**TOWN OF WELLINGTON
PLANNING COMMISSION**

Date: September 14, 2020
Submitted By: Cody Bird, Planning Director
Subject: Preliminary Plat of Sage Meadows Second Subdivision

Date: September 14, 2020
Submitted By: Cody Bird, Planning Director
Subject: Site Plan Review: Lot 4, Wellington Business Center

WELLINGTON BUSINESS CENTER
Fixture Height: 15FT WALL PACKS, 25 POLE MOUNT FIXTURES

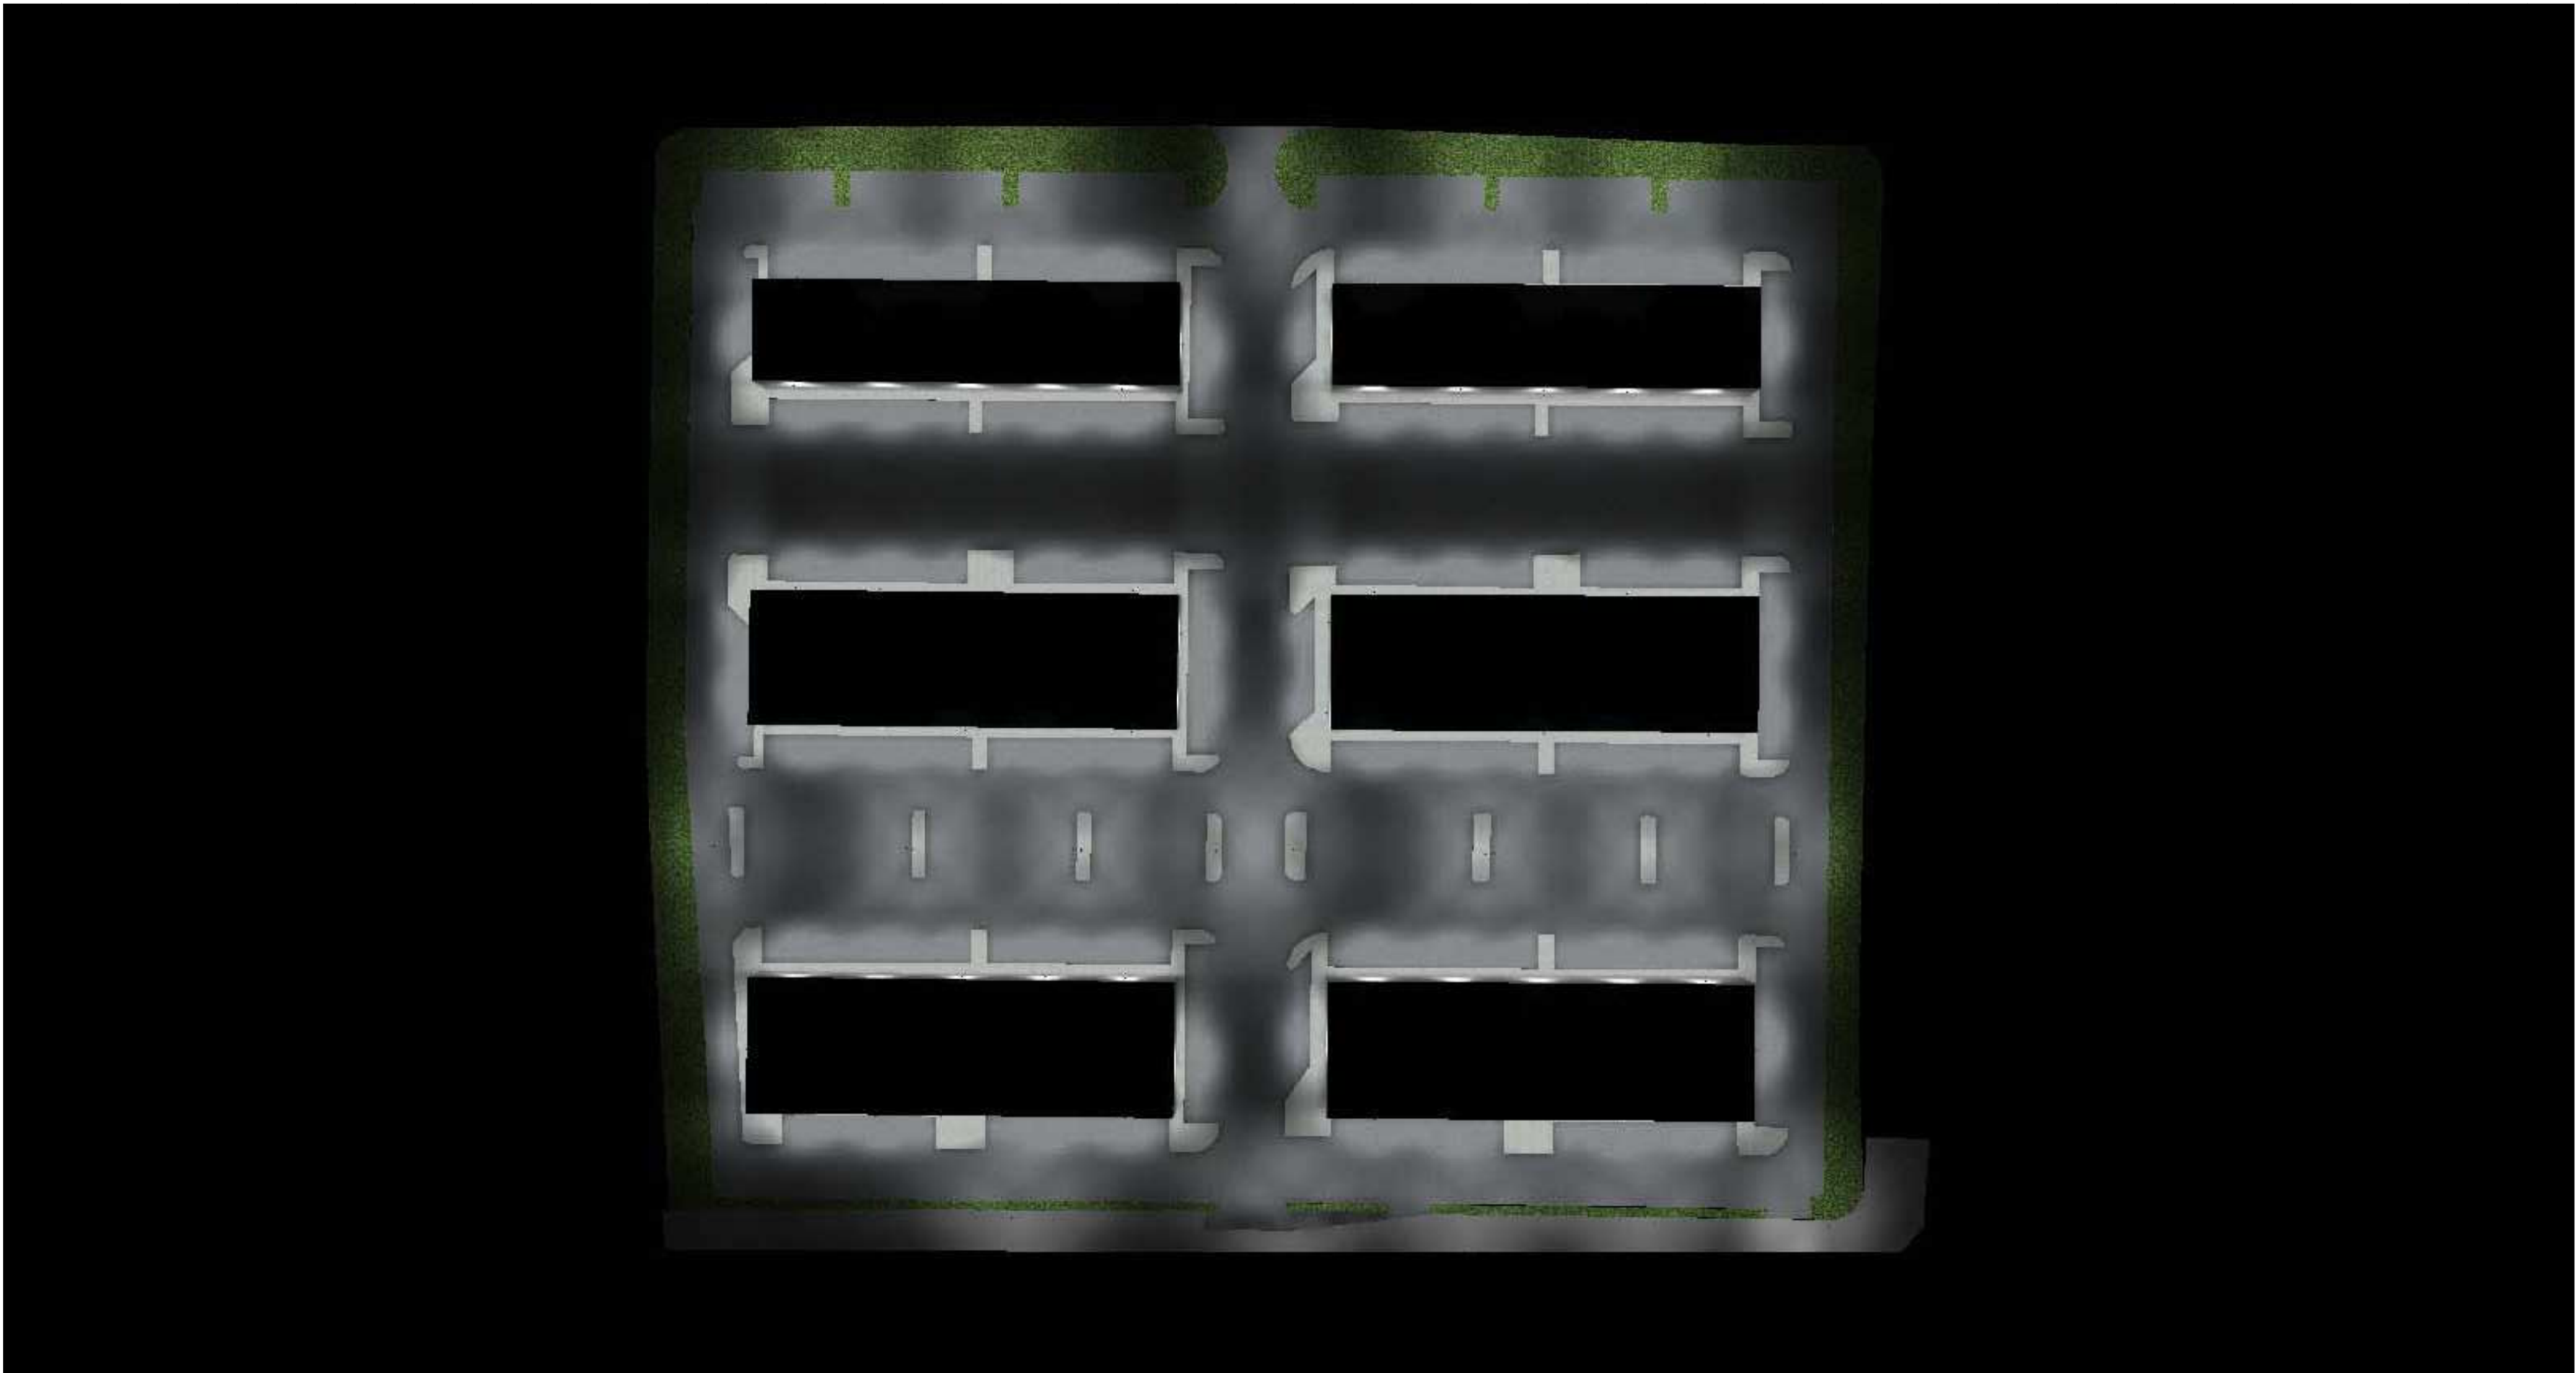
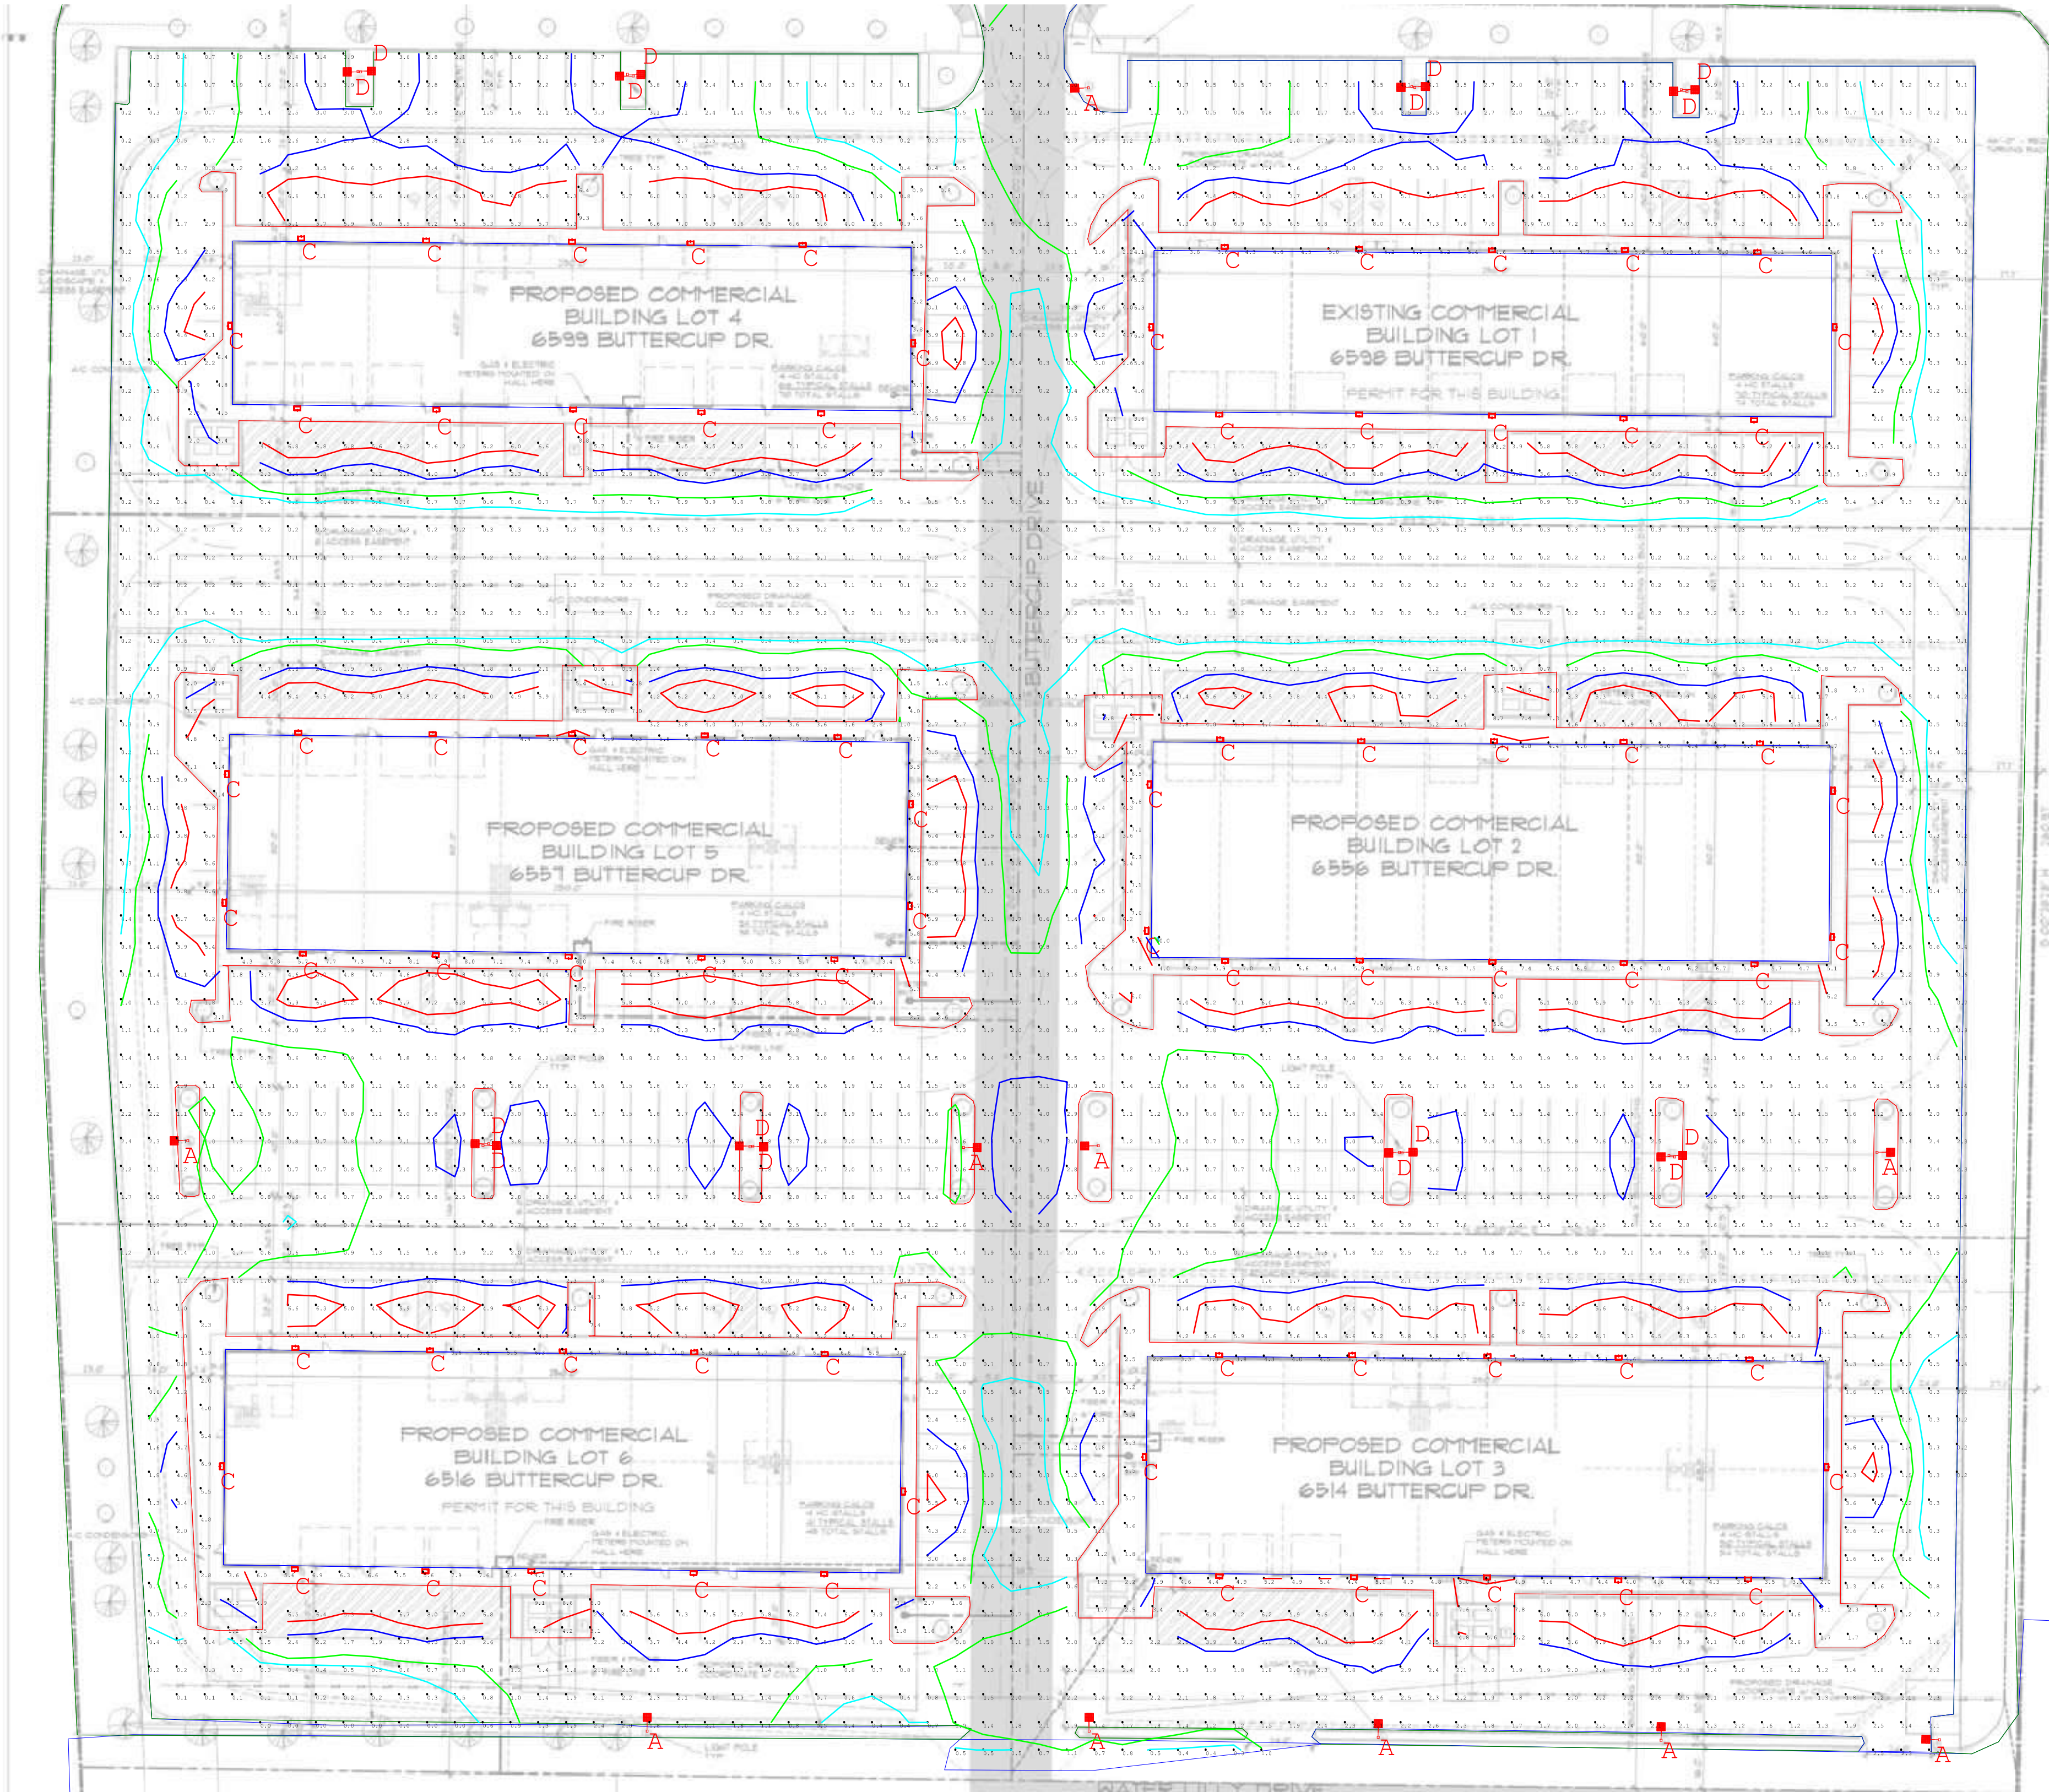
9. Site Lighting: A photometric plan was provided with the site plans as required.
- The Town's maximum illumination level at the property line is 0.1 footcandle. There is a minimal amount of light spill over onto Wine Cup St. right-of-way. The additional lighting levels along Wine Cup are acceptable and will benefit lighting the sidewalk at this location.

- Site Trees:
 - A sufficient number of parking lot trees are identified for Lot 4 and Lot 5. Trees in the bulb-outs along Wine Cup St. conflict with light pole locations - The applicant shall verify the trees will not obstruct the lighting when mature, or alternative locations for the trees shall be identified.
